Holtec Center, 555 Lincoln Drive West, Marlton, NJ 08053

**Subject:** Response to Request for Additional Information on HI-STORM 100 System (100U License Amendment Request 1014-6), USNRC Docket 72-1014, TAC NO. L24085

Document ID 5014674

## Holtec Response to NRC RAI

*Figure 3.1.13; MPC Guide/MPC Impact LS-DYNA Model*

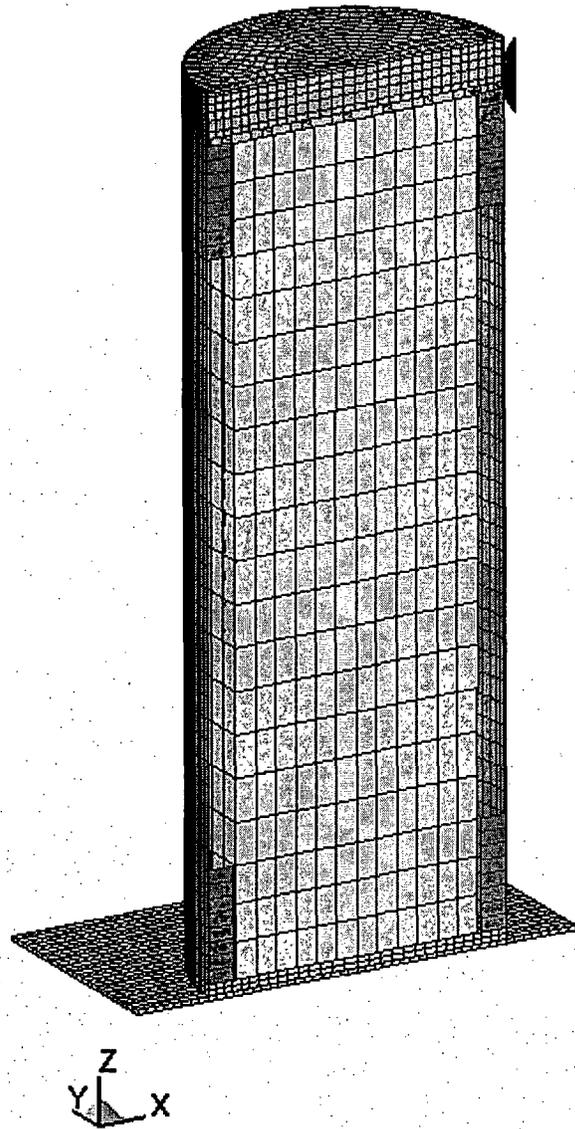
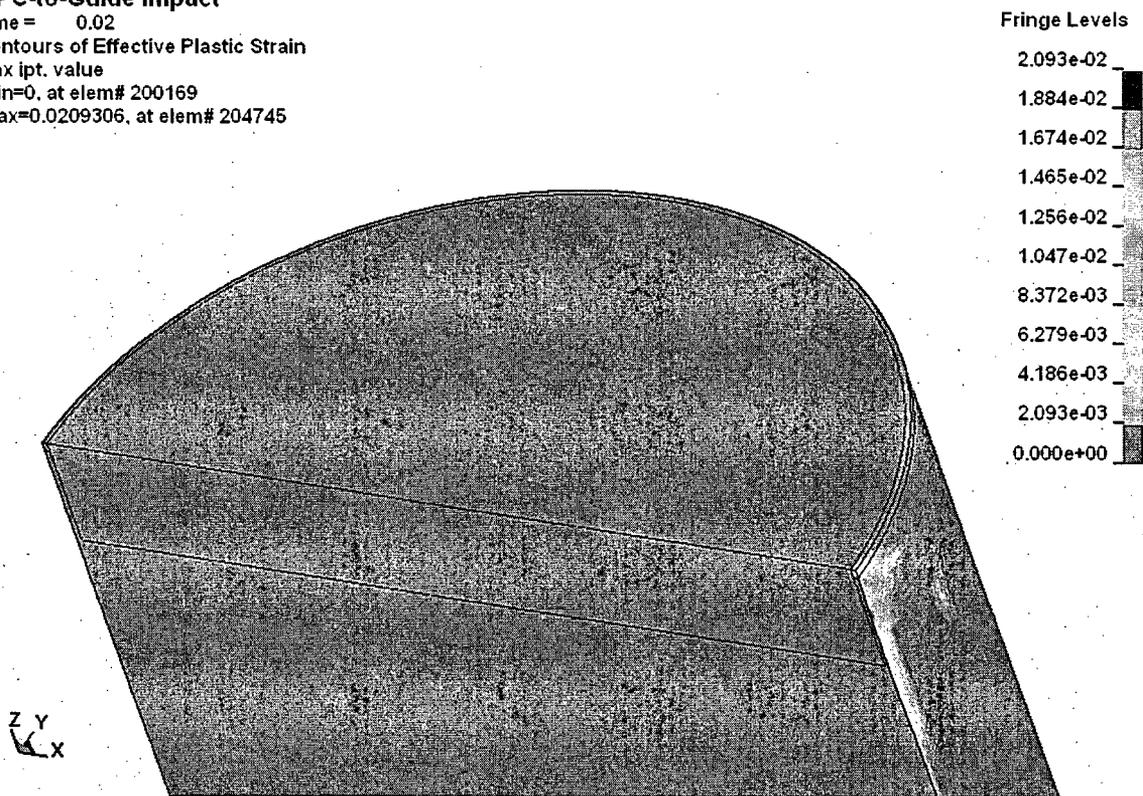
**3-1** Revise the stress analysis of the MPC confinement boundary in Calculation-07 of Calculation Package HI-2053389 to incorporate an evaluation of the maximum stresses occurring in the Multi-Purpose Canister (MPC) shell during the seismic event.

**3-2** For the LS-DYNA seismic model, provide a convergence study to demonstrate that the maximum stresses in the MPC shell elements in the vicinity of the impact with the MPC Guide Ribs are reasonably accurate.

**Holtec Response to 3-1:** The local response of the MPC Confinement Boundary (Enclosure Vessel) to the MPC/MPC guide impact under the seismic event has been re-analyzed using a highly discretized grid with fully integrated finite elements and elasto-plastic material properties. The upper region of the confinement boundary subject to impact from the MPC guide plates has been meshed with even smaller elements. The emphasis in the newly performed confinement boundary integrity analysis is to determine if the localized strains in the region of impact would threaten the integrity of the confinement boundary. The input impulse due to the impact between the MPC and the guide is simulated in a manner to maximize its value, as fully described in the new material added to paragraph 3.I.4.7.3 in the FSAR.

**Holtec Response to 3-2:** As mentioned in response to RAI 3-1, a refined mesh for the MPC Confinement Boundary with fully integrated elements has been prepared and the local impact problem has been analyzed to determine local strains. The number of thru-thickness integration points has been set at the maximum available (10). A mesh convergence study has been performed using a finer grid size to verify that the results are acceptable. The new analysis, described in paragraph 3.I.4.7.3 would allay Staff's concern with respect to convergence and safety margins in the confinement boundary during the seismic event.
